HISTORIC AND DESIGN REVIEW COMMISSION

May 01, 2019

HDRC CASE NO: 2019-223
ADDRESS: 517 E HOUSTON ST
LEGAL DESCRIPTION: NCB 422 BLK 26 W 26 FT OF 5 ARB A2
ZONING: D, H, HS
CITY COUNCIL DIST.: 1
DISTRICT: Alamo Plaza Historic District
LANDMARK: Rosenberg, Frank Building
APPLICANT: Michael Litofsky
OWNER: Michael Litofsky
TYPE OF WORK: Front Facade Reconstruction, including removal of ClearBoarding for compliance
APPLICATION RECEIVED: April 17, 2019
60-DAY REVIEW: June 16, 2019
CASE MANAGER: Huy Pham

The applicant is requesting a Certificate of Appropriateness for approval to construct the storefront at 517 E Houston in accordance with plans approved by the HDRC on May 20, 2015 and a timeline of compliance. This request is a result of a municipal court case filed for the installation of ClearBoarding prior to approval.

- 1 CLEAN AND RESTORE EXISTING BRICK
- 2 REPLACE WINDOWS
- 3 RESTORE SCUPPER, DOWNSPOUT AND DOWN LEADER
- 4 NEW DOORS

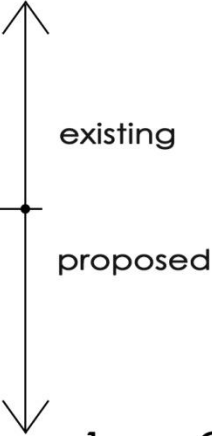
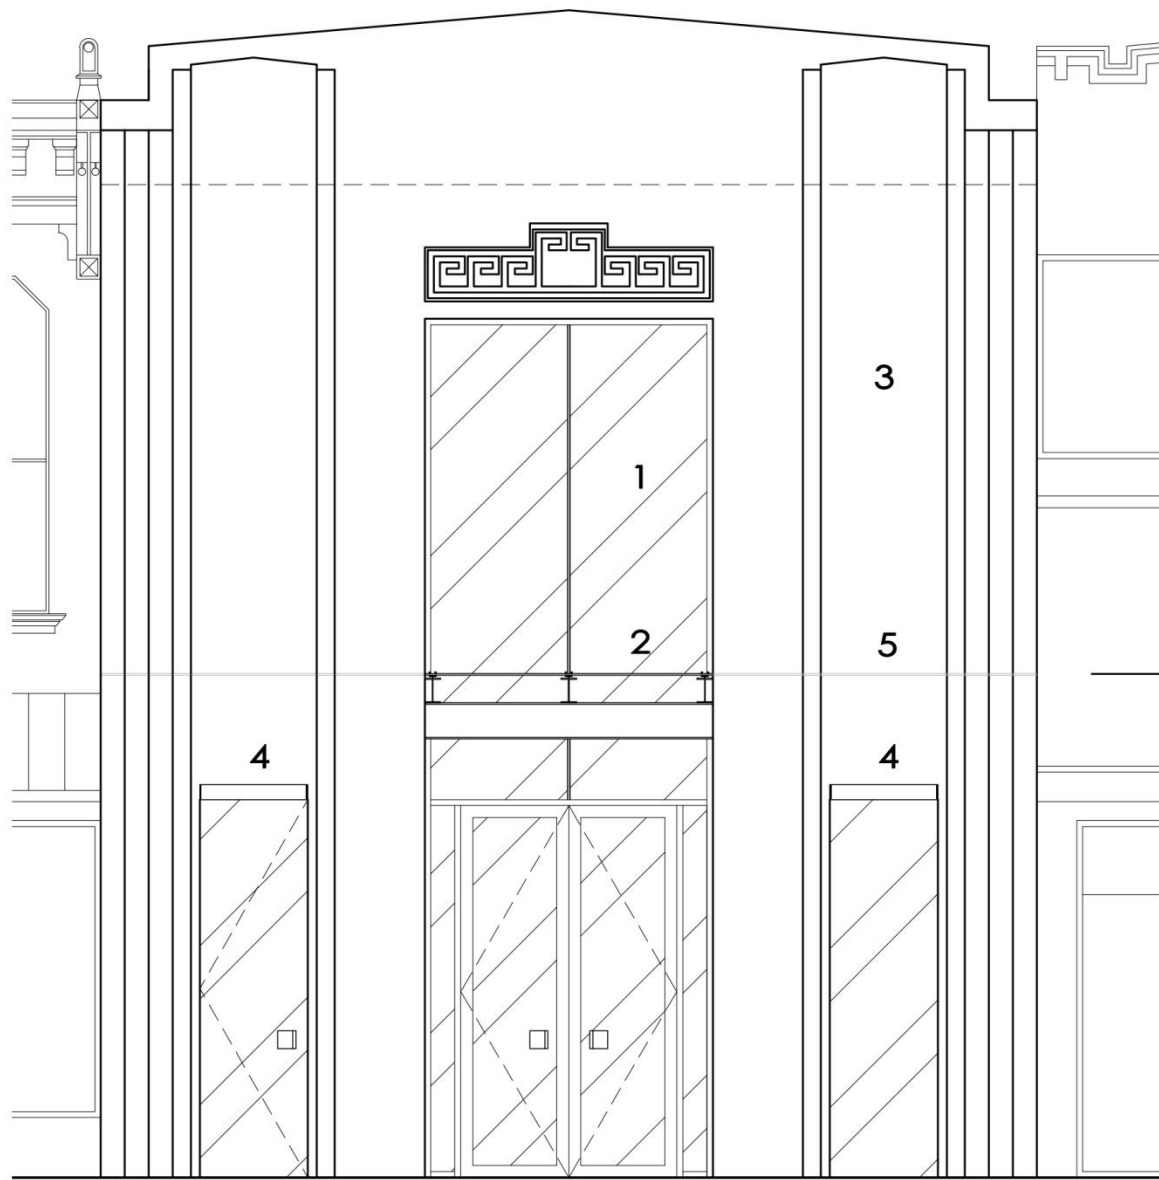
- a. **FAÇADE MATERIAL RESTORATION** - The applicant has proposed to restore the existing plaster façade which fronts E Houston as well as to restore the existing rear brick façade which fronts Peacock Alley. This is consistent with the Guidelines for Exterior Maintenance and Alterations 2. A. and 2.B. and 10.B.ii.

- i. **GUTTER SYSTEM** - The applicant has proposed to restore the scuppers, downspouts and down leaders of the existing gutter system. While those that are currently on the façade are not historic, their repair is consistent with the Guidelines for Exterior Maintenance and Alterations 4.A.

- b. **SIGNAGE** - The applicant has noted in the application materials that the existing signage on the Peacock Alley façade which reads “SOL FRANK Company” is to be restored. While not original to the façade, this signage has historic value and should be restored with the restoration of the brick façade. This request is consistent with the Guidelines for Signage 1.B.i. and ii.

- m. **NEW WINDOWS** - According to the Guidelines for Exterior Maintenance and Alterations, new windows that match the historic windows of a structure should be installed when the existing windows are missing or deteriorated beyond repair. The applicant has proposed to install new one over one wood windows on the Peacock Alley (rear) façade of the structure. This is consistent with the Guidelines for Exterior Maintenance and Alterations 6.B.iv.

- n. **NEW DOORS** - The applicant has proposed to install two (2) new doors on the Peacock Alley façade. While this is the rear of the building, in this instance the rear is proposed to be treated as the front also. The Guidelines for Exterior Maintenance and Alterations 6.A.i. does not recommend that new entrances be created where visible from the public right of way. This proposal is not consistent with the Guidelines. Staff recommends that the applicant keep the existing door openings and widths.

Staff recommends approval of storefront reconstruction from the 2015 approved plan set (itemized in finding e, excluding rear door modifications) based on findings c through n with the following stipulations:

- 1 CLEAR GLASS
- 2 GLASS CANOPY
- 3 EXISTING PLASTER
- 4 EYEBROW CANOPY - GLASS
- 5 HORIZONTAL CONTROL JOINT

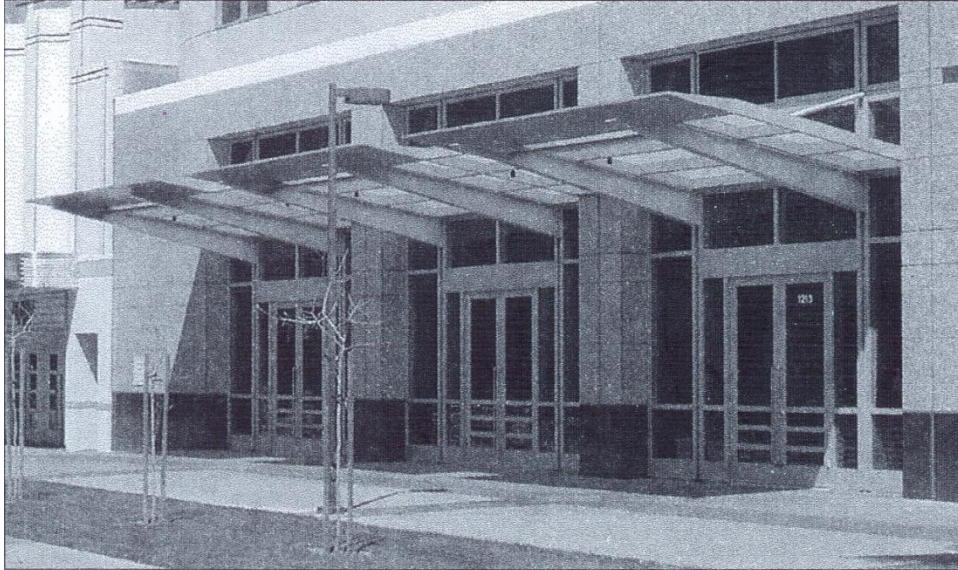
- j. **SECOND FLOOR WINDOW** - The applicant has proposed to install clear glass on the Houston Street façade where a second level clear storefront glass would have once been located. The Guidelines for Exterior Maintenance and Alterations 10.A.iii. states that missing features should be replaced in to match the style of the building and the period in which it was designed. Staff finds that the applicant’s proposal is appropriate and consistent with the Guidelines.

- k. **CANOPY** - Per a photograph dated October 2007, the Houston Street façade at 517 Houston featured a canopy which projected approximately eight (8) feet out over the sidewalk, which has since been removed. The applicant has proposed to install a projecting steel and glass canopy which is to extend over the sidewalk approximately five (5) feet and feature three (3) sections to correspond with the entrance way and the proposed new clear glass. While the profile and materials are not alike in materials to the original historic façade, staff finds that the light appearance of the thin steel and glass canopy does not distract from the historic façade and is appropriate in this instance.

- l. **STOREFRONT** - While currently covered by plywood, the storefront façade at 517 E Houston features a recessed storefront entrance. Other storefront entrances on E Houston do not feature entrances nearly as deep as this one, which leads staff to believe that 517 E Houston’s storefront entrance is not an original element of the building’s

GLASS CANOPY DETAIL

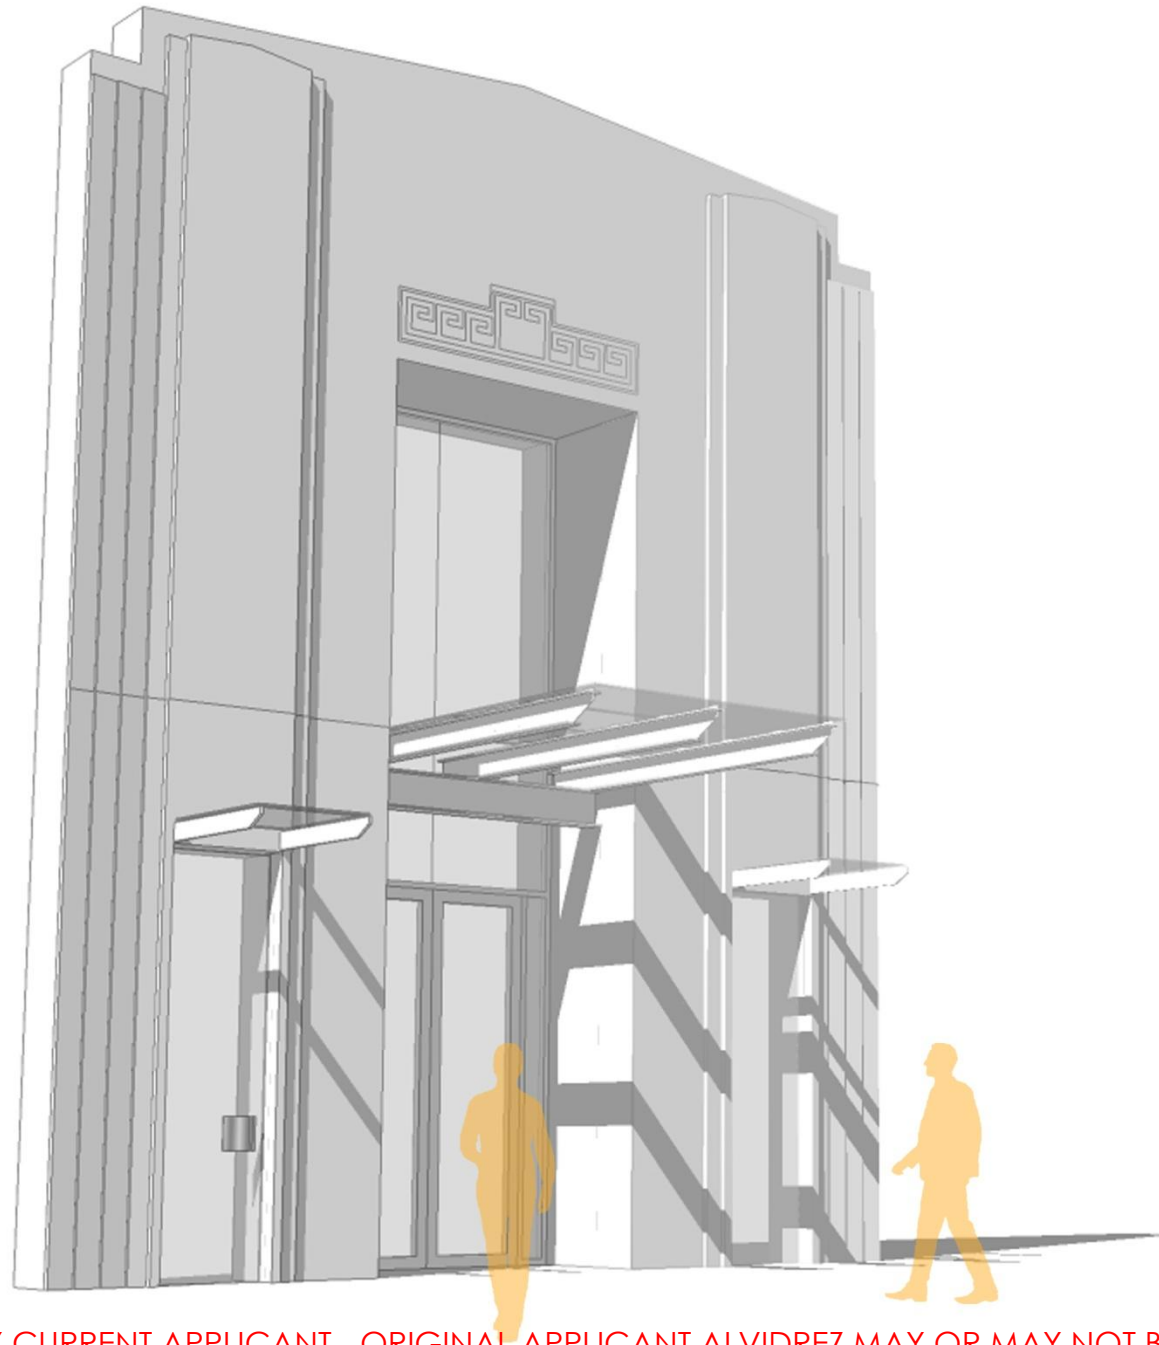
- h. **DESIGN REVIEW COMMITTEE** - This request was reviewed by the Design Review Committee on April 7, 2015. At the meeting, committee members noted that proposed glass canopy was appropriate given its lightweight appearance and that it would be best to not alter the original fenestration at the rear of the structure.
